**JOINT MEETING:**

**COMMISSION OF ARCHITECTURAL REVIEW  
&  
RIVER DISTRICT DESIGN COMMISSION**

**December 11, 2025  
3:30 PM**

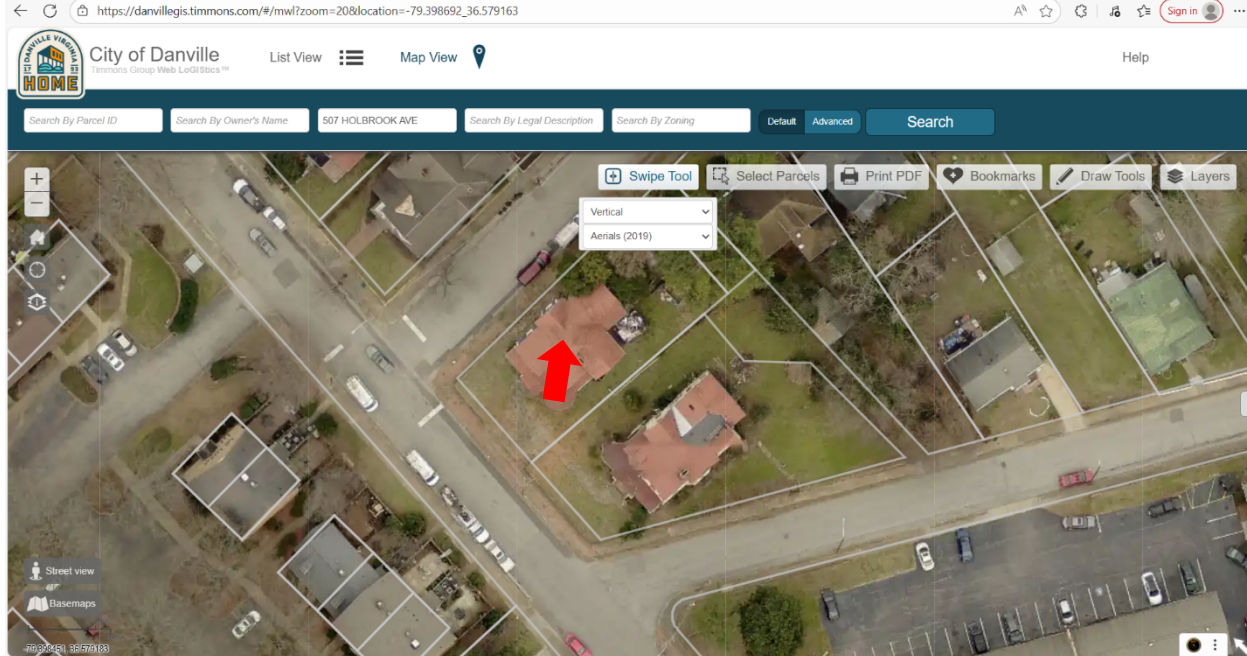
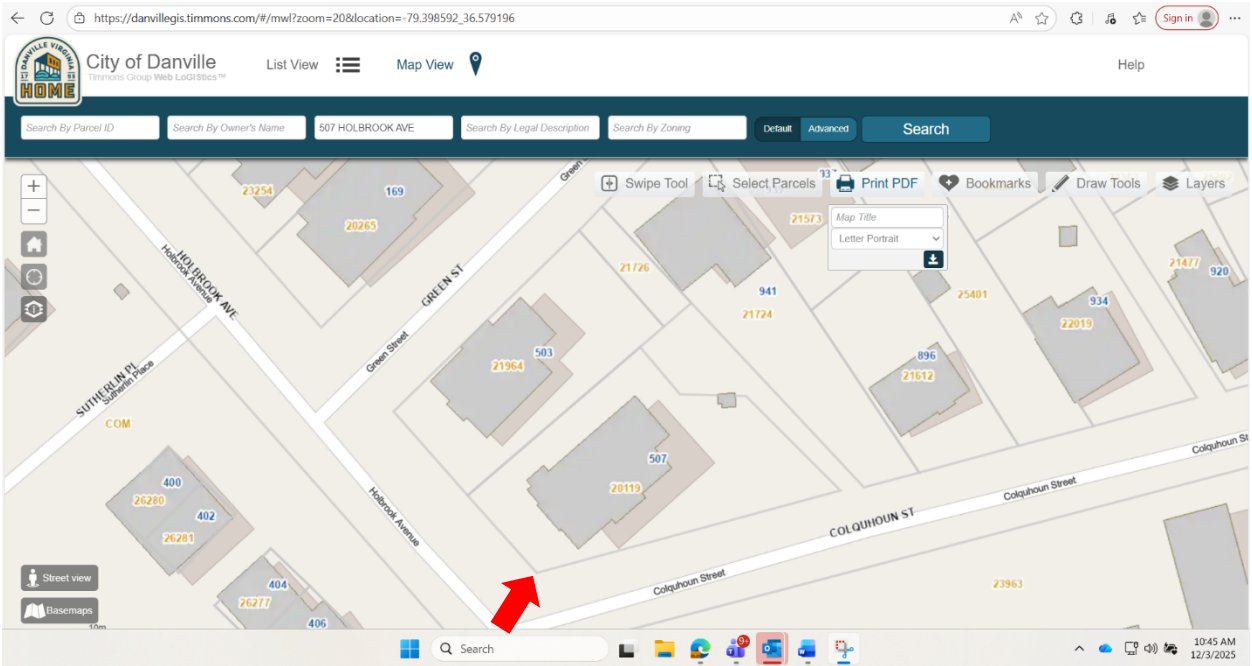
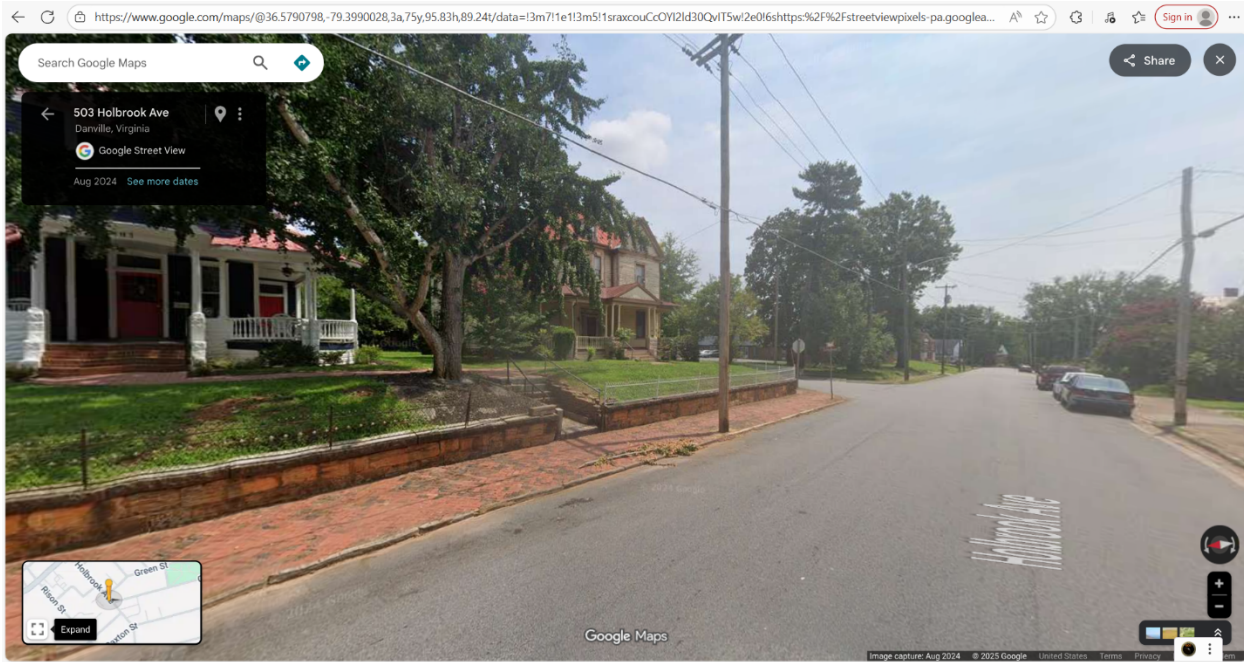
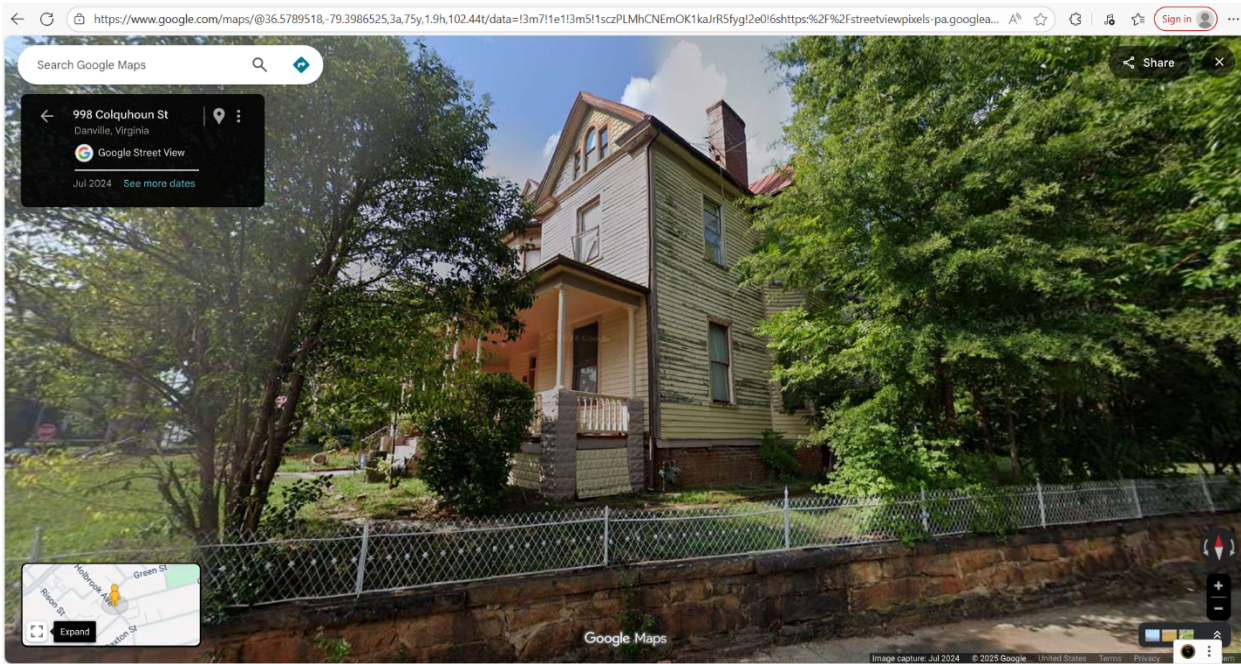
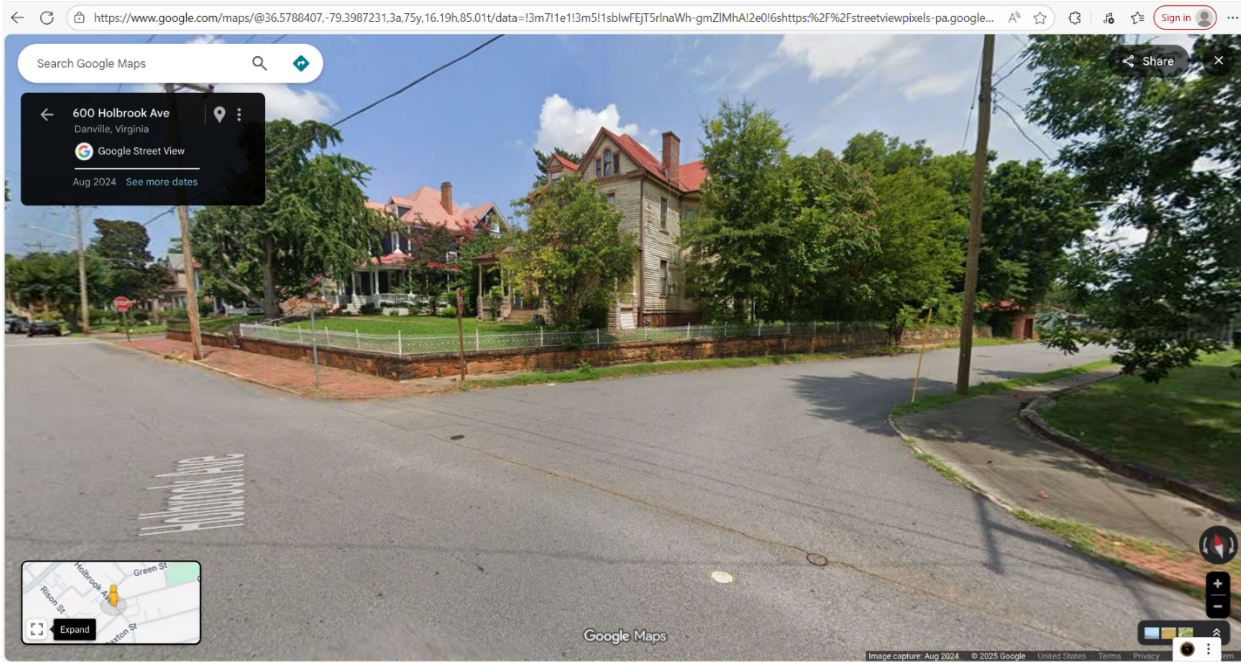
The applicant seeks a Certificate of Appropriateness to replace the existing sheet metal roof with a painted steel roof at 507 Holbrook Avenue. The proposed roof will be painted charcoal gray.

The Planning Division staff recommend approval of Certificate of Appropriateness application PZ25-00583 to replace the roof at Parcel 20119 (507 Holbrook Avenue).

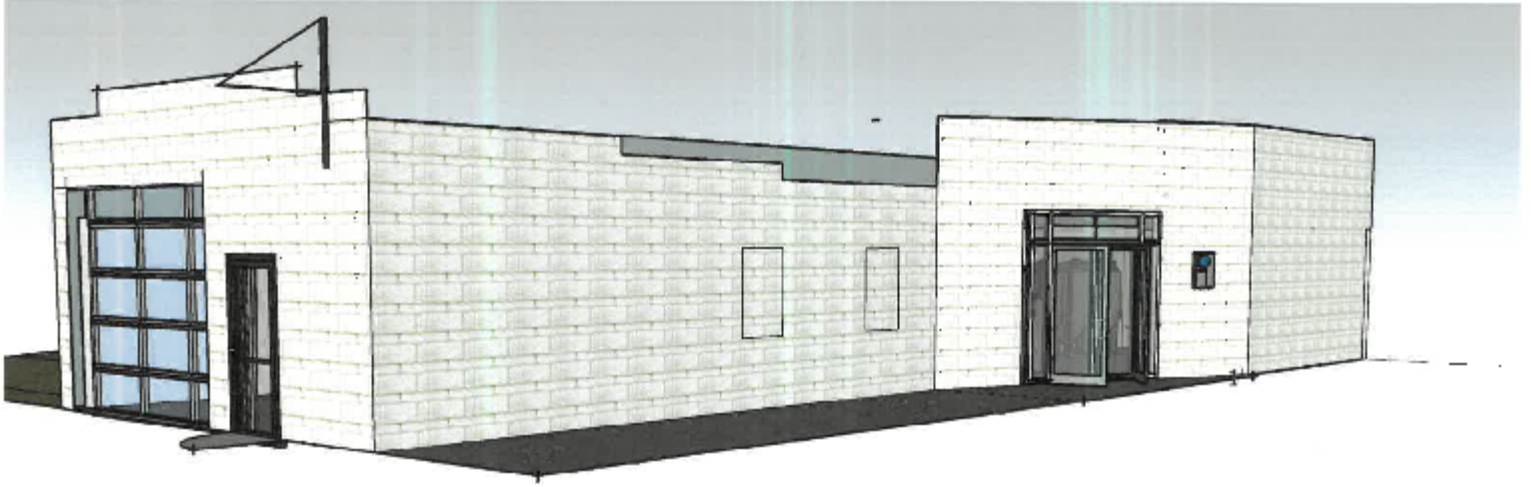
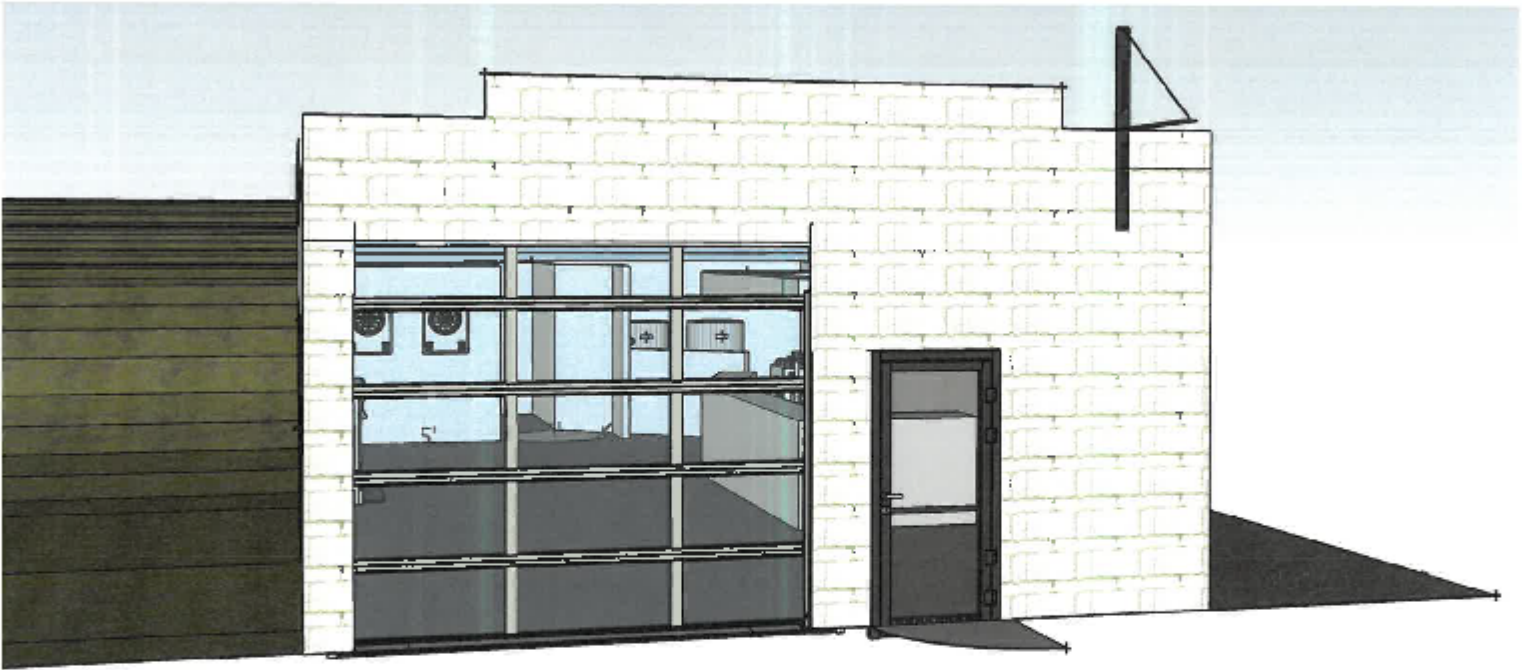
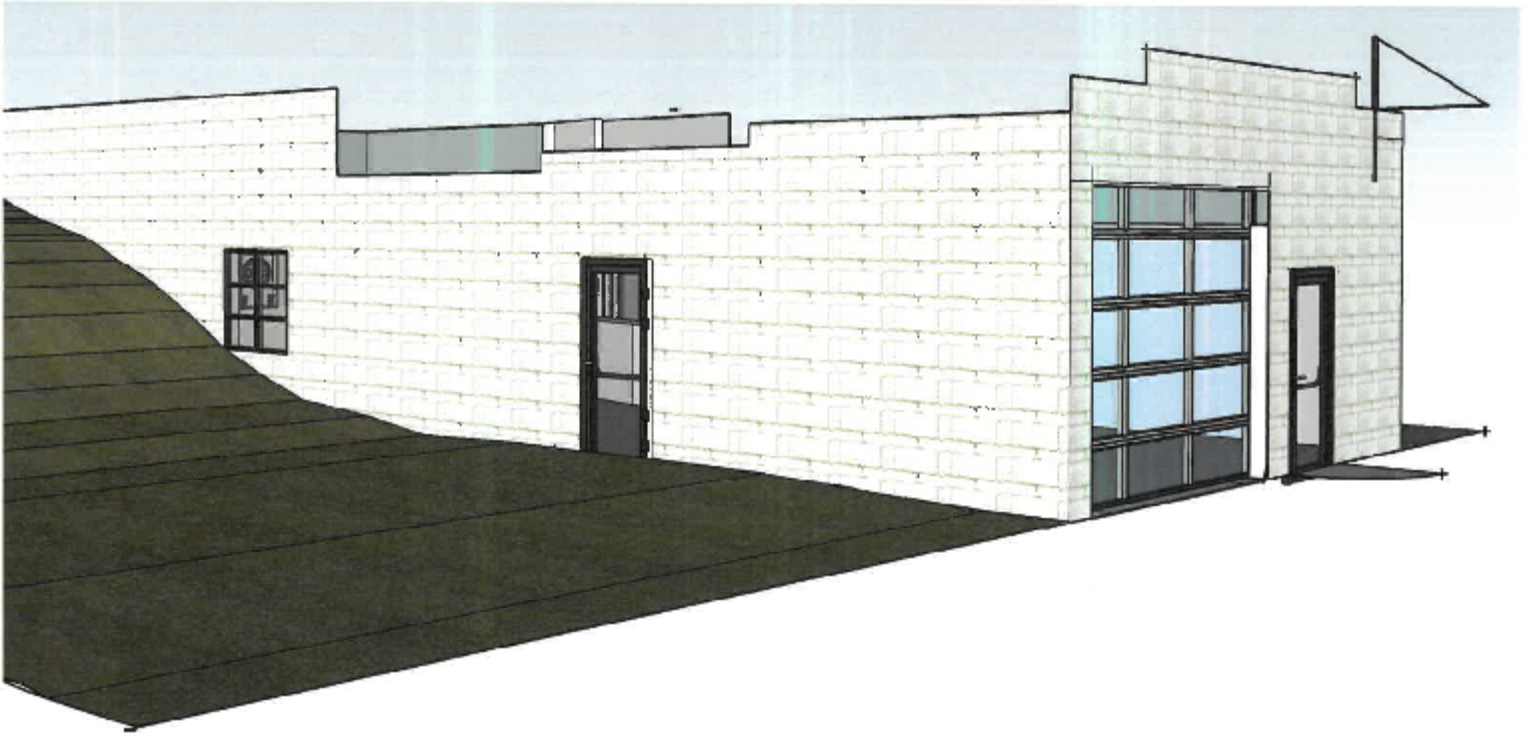
1. Replace solid garage door on front façade with glass door
2. Replace solid metal door with metal and glass storefront style door
3. Replace window on southern façade with new metal window
4. Replace window on southern façade with new metal and glass storefront door
5. Remove 2 windows on northern façade and fill with block to match existing wall
6. Replace solid garage door on northern façade with metal and glass store style entry and door, including glass sidelights and glass transom
7. Install projecting sign on existing sign pole, painted sign above garage door, and painted mural on side wall of building

Improvement Description: Rebuild 1 garage door with Glass Door / Remove 2 windows  
Replace metal entry door with Glass stor front door.  
Replace Rear / side Garage door with Glass stor front.  
Add 1 door on left side of building and replace window with metal and glass window

The Planning Staff recommends approval of PZ25-00600. The replacements presented use materials and styles to maintain the industrial character of the structure. The proposed changes provide an attractive appearance for future commercial use.
